RECOMMENDATION ON LOCATION OF COMMON DATA CHAMBER

DXC-0636
COPY 1 OF 4

FIG. 1 - PRESENT DATA CHAMBER & SLIT LAYOUT

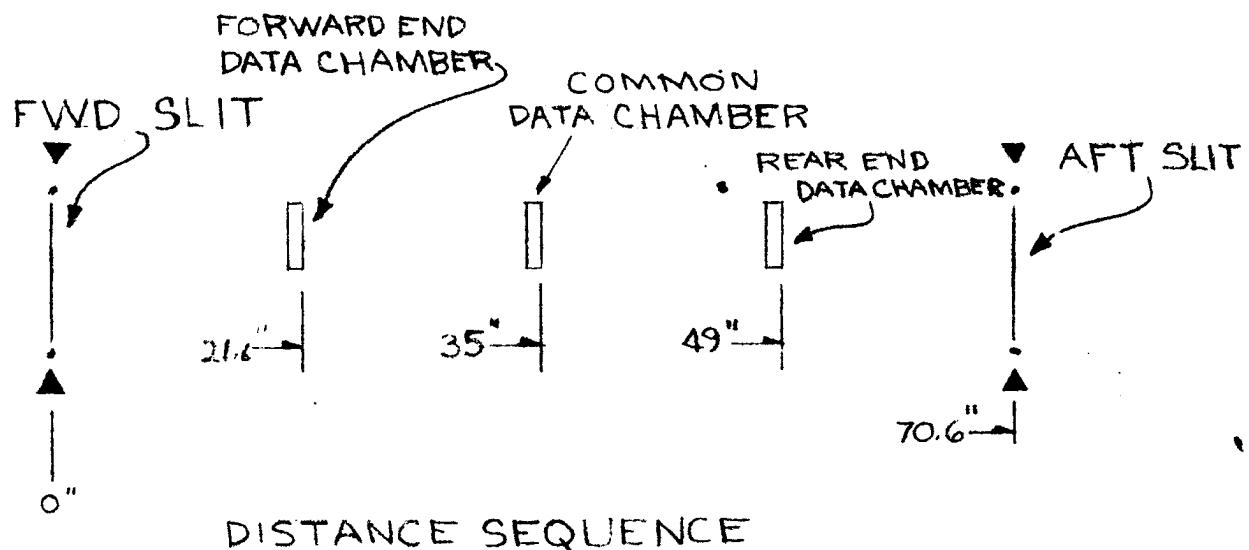
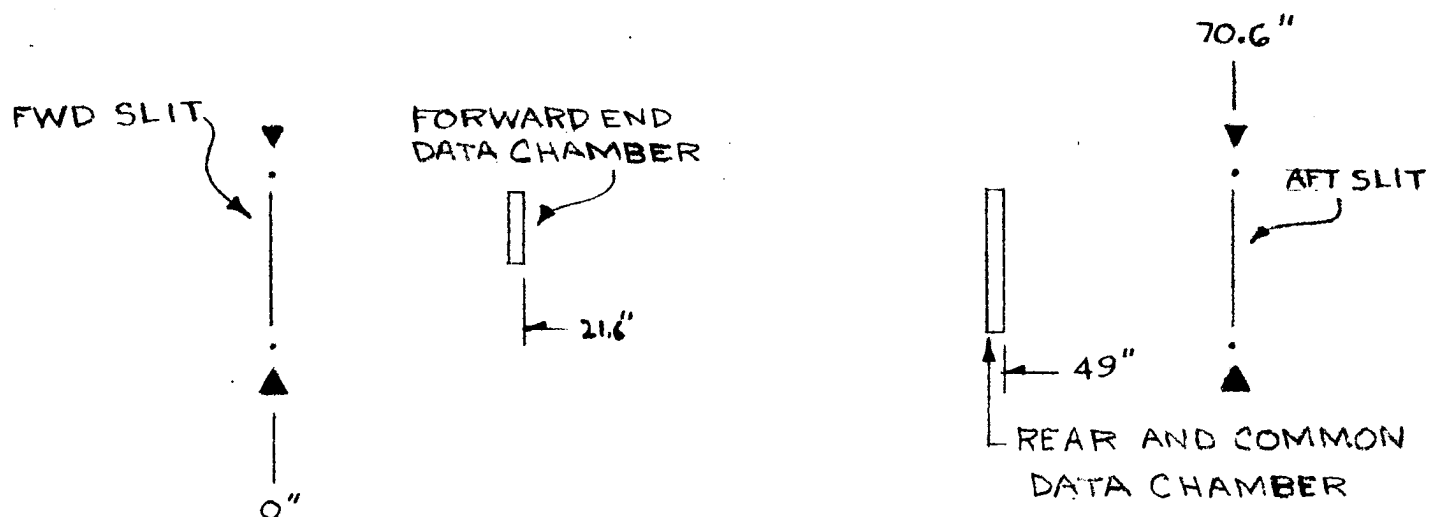
At present the requirement that common data (longitude, latitude, ground speed, etc.) be photographed at plus or minus a fixed time interval from the nadir of each frame has forced us to retain the common data chamber as separate from the rear end data chamber.

We recommend that this requirement be modified so that the common data chamber is photographed at the same time and place as the rear data chamber. Such a timing results in the common data photograph appearing 90/180 γ or $\frac{1}{2}$ cycle after the forward unit nadir (about 3 seconds), but at the same time as nadir for the rear unit. At present common data is to be flashed at $\gamma/4$ after nadir on forward unit frames, and $\gamma/4$ before nadir on rear unit frames.

1. Elimination of an optical system by combining the image system of "common" and "rear end" data chambers into a single projection system.
2. Increase in reliability by eliminating requirement for separate pulsing circuits, "A part that isn't there can't fail".
3. Weight and power saving by combining the two flash units now required into one. Estimated savings $\frac{1}{2}$ pound weight, 10 watt power.
4. Increased ease of testing and maintenance, combining the two data chamber power supplies, projection and control mechanisms, reduces mechanisms and elements by almost 50%.

It is not known by us what advantages may exist in flashing approximately $1\frac{1}{2}$ seconds before nadir on one frame and $1\frac{1}{2}$ seconds after nadir on neighboring frames versus, flashing at nadir on one frame and three seconds after nadir on neighboring frames.

NOTE: RESULTING FILM FORMAT SAME IN BOTH CASES, ONLY CHANGE IS REAL TIME AT WHICH COMMON DATA IS PHOTOGRAPHED.
